OFFICIAL COORDINATION REQUEST FOR NON-ROUTINE OPERATIONS AND MAINTENANCE

COORDINATION TITLE- 16BON49 summer spill change

PROJECT- Bonneville Lock and Dam

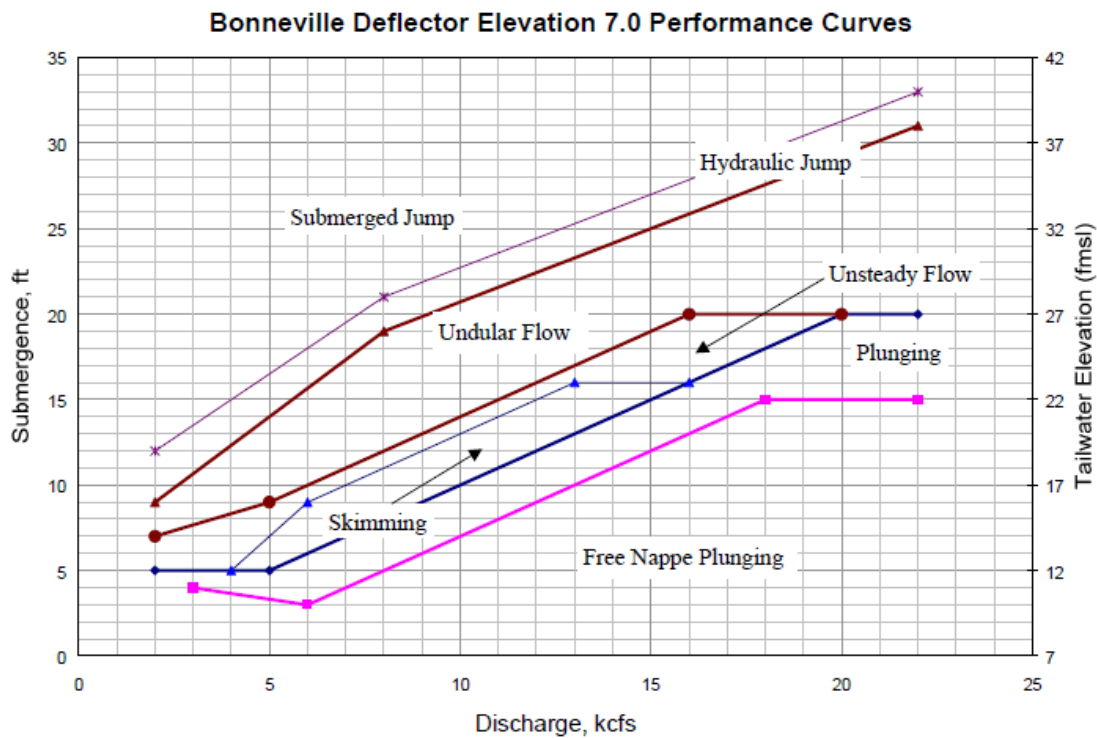
Description of the problem - Erosion holes have been observed in the previously repaired area of the B-Branch riprap. These holes were not observed during the May spillway inspection. Due to the water movement in the eroded areas, there are concerns that the undercutting may extend further beneath the ladder structure. Please see the photos of the erosion areas below.

An investigation as to the cause of the erosion has just begun but there is too much energy being dissipated at the erosion locations. The attached diagram is from the Bonneville Deflector DM (2001). The diagram shows that the flow conditions off of the 7 foot deflector are unsteady (turbulent) for the conditions that have existed much of the past month (17 foot tailwater and about 6600 cfs through Bay 18). Tailwater is expected to drop as we move into July and August; the lower tailwater should help with the unsteady flow. Any change in discharge through Bay 18 also causes an increase in turbulence (energy dissipation). Using a constant spill operation eliminates the additional turbulence associated with gate changes.

In order to minimize the current rate of erosion, the Corps plans to modify the current summer spill operation (alternate every two days between 85 kcfs day/121 kcfs night and 95 kcfs 24 hours per day) to a constant 95 kcfs 24 hours per day effective 8 July through 31 August. Changing to a constant spill operation of 95 kcfs 24 hours per day is needed for the following reasons:

Type of outage required - No outage. From July 8 through August 31, implement a constant spill operation of 95 Kcfs 24 hours/day, rather than alternating every two days with the 85 Kcfs day/121 Kcfs night treatment.
